Ecolog Battery Information

ELPRO-BUCHS AG

13.09.2007

Technical modification at the lithium battery, Part-Nr.: 2820 (2819)

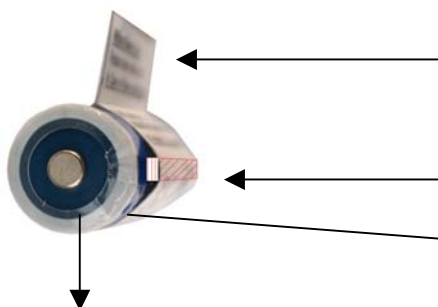
This is needed to prevent the shifting of the Battery inside the holder.

Under the label of the battery is now a flat pin. This pin prevents that the lithium battery in the mounting plate can shift. The battery can not move any more, caused from a shock or push during a transportation for example. The contacts can not be interrupted.

Correct inserting of the lithium battery into the ECOLOG:

1. The end of paper must be on the top, so that the battery can be pulled out of the mounting plate

2. The pin must be situated laterally.

3. Press the battery straight downward into the mounting plate

Like this is no shifting of the battery possible
